# SPIRE

## SPIRE PROJECT DOCUMENT REDEFINITION OF THE SHUTTER SUBSYSTEM

Ref: SPIRE-USK-NOT-000002

This document proposes a revision of the rationale for the SPIRE shutter subsystem. Revised requirements and interfaces are proposed.

Figure 3: **Shutter location.** The shutter will be located near the focal surface of the FIRST telescope.

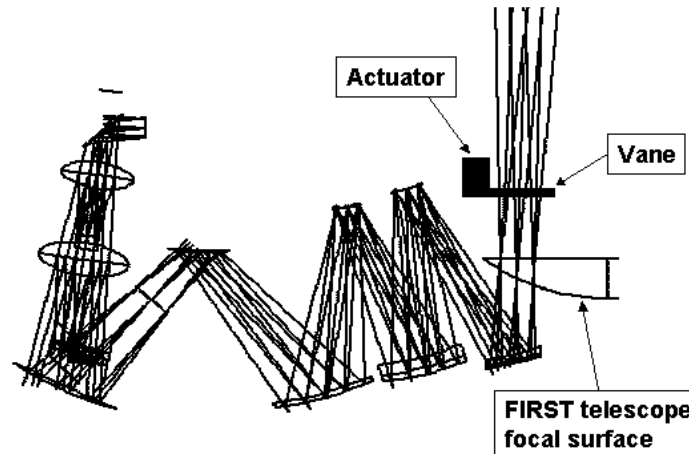
Since AD1 was issued, the shutter has been moved to a different location: the current design has it in the fore-optics of the instrument such that it will be the first optical element encountered

by the input beam (Figure 3). The shutter thus has two roles:

This change has profound implications since it significantly alters the requirements to be placed on the shutter. For one thing, moving the shutter to the fore-optics permits the on-board calibrators to be used simultaneously, so there is no longer any need for the shutter to provide a calibration signal.

The most significant effect of the change of location is that there is now little need for the shutter to be flight capable. Once the instrument is in orbit the background flux will be provided directly from the telescope itself. The only cases in which we might want to activate the shutter are:

We therefore propose that the shutter be designated for ground use only. The case for flight use is weak and the technical and programmatic costs associated with flight capability are high.

Figure 4: **Shutter block diagram.** The shutter subsystem will be connected to its control system through the cryoharness and the DRCU.

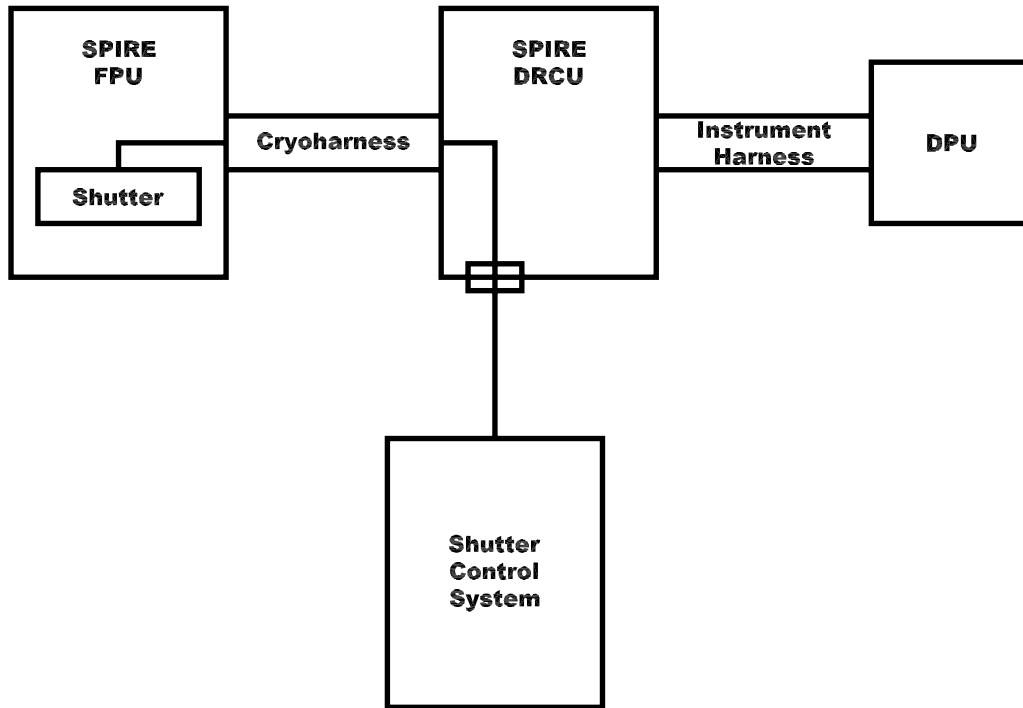
The current version of the SPIRE Interface Matrix specifies that the shutter subsystem has interfaces with 8 other SPIRE subsystems (AD3). If the shutter is designated for ground use only, then there will be fewer interfaces and the nature of those that remain will change. The interfaces are discussed individually in Table 5. A block diagram of the instrument, indicating the shutter control configuration, is given in Figure 4.

Interface	Description
DRCU	The DRCU will not contain any electronics for the subsystem. Wires for the shutter subsystem will be routed through the DRCU from the cryoharness to a test connector.
OBS	This interface should be deleted.
FPU simulator	This interface should be deleted.
DRCU simulator	This interface should be deleted.
Instrument Interface Document	This interface remains since the cryoharness will contain wires for the shutter subsystem.
Structure	The shutter subsystem will be mechanically attached to the SPIRE instrument structure. This interface will specify the attachment details, volume, mass, etc. It will also specify the routing of the shutter wiring harness.
Optics	The shutter interfaces with the optical system since its purpose is to reject the incoming beam and illuminate the detectors with a background flux. The location of the shutter vane will be specified through this interface.
